**Question(s):** 12/15**LIAISON STATEMENT****Source:** ITU-T Study Group 15**Title:** Comments on draft-ietf-mpls-tp-framework-10 [Ref #015.02]

**LIAISON STATEMENT****To:** IETF MPLS WG**Approval:** Q12/15 (by correspondence)**For:** Action**Deadline:** 12 April 2010

The experts of Q.12/15 have reviewed draft-ietf-mpls-tp-framework-10 by correspondence and have some comments and proposed changes shown in the attached marked up draft. We have also identified some major open issues and areas where we request clarification as listed below. These proposals reflect the consensus view of the experts.

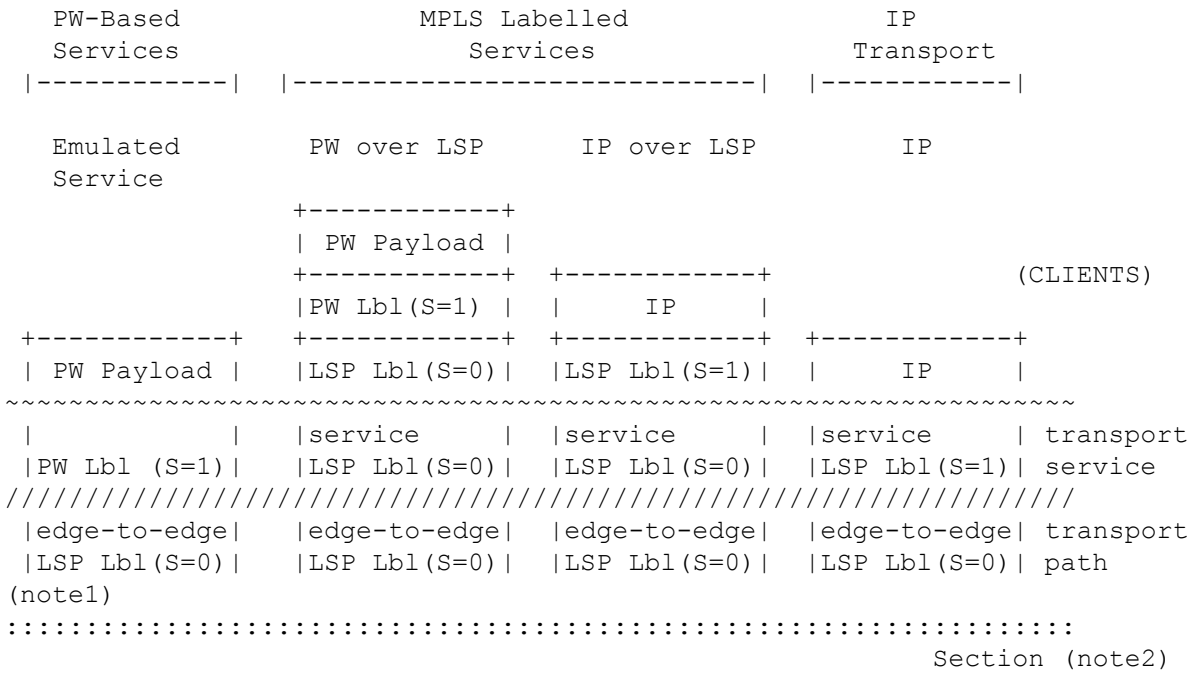
#### SS-PW over a multi operator LSP:

draft-ietf-mpls-tp-framework-10, section 3.4 “MPLS-TP Native Service” describes the following MPLS-TP architectures:

1. SS-PW (figure 6)
2. MS-PW (figure 7)
3. architecture for Network layer clients (figure 9)

Please confirm that running a SS-PW over an LSP used as transport service layer rather than as transport path layer is allowed. We intend to describe this scenario in G.8110.1, do we need an additional figure in the draft to explicitly support this configuration.

Figure K: MPLS-TP edge-to-edge LSP transporting PW, Service-LSP and Ethernet VLAN transport service layer transport path signals

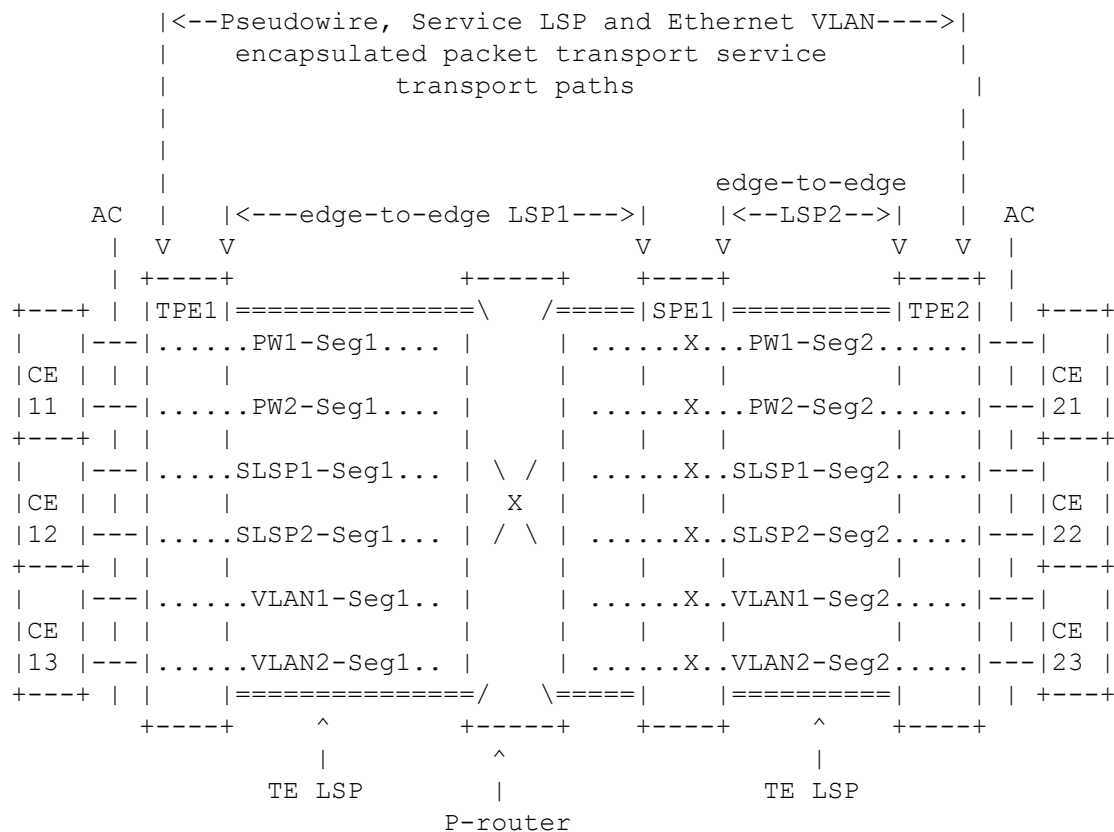
And the inclusion of a new figure:

The three transport service layer transport path signals (PW, Service LSP and Ethernet VLAN) are transported through e.g. an edge-to-edge LSP based transport path layer transport path. It is important to realize that those three service layer transport path signals co-exist in their server layer transport paths. To make this explicit it is proposed to add the following figure to the framework document:

Please confirm an expansion of the figures from the draft into the figures shown above that will be included in G.8110.1 is acceptable.
